Planning Commission Staff Report

March 11, 2009
Item 6. a.

- SUBJECT:** PDR-804/PCUP-233
- APPLICANT:** Tom Kubo/William Wood Architects
- PROPERTY OWNER:** Dan Yoon
- PURPOSE:** Applications for design review approval to construct an approximately 6,080 square foot building for Hana Japan Steak House and a conditional use permit to serve alcohol after 10:00 p.m.
Consideration of Negative Declaration.

- LOCATION:** 11991 Dublin Canyon Road
- GENERAL PLAN:** Retail/Highway/Service Commercial; Business and Professional Offices
- ZONING:** C-C (Central Commercial) District and PUD-O (Planned Unit Development –Office) District

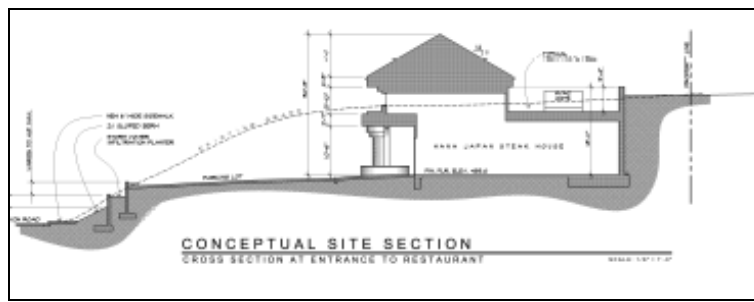
Staff would like to note that portions of the landscaping site plan are slightly inconsistent with the site plan. Some of the planter areas are not shown on the landscaping plan yet shown on the site plan. Staff has added a condition of approval requiring that the landscaping plan to be consistent with the site plan and the grading plan.
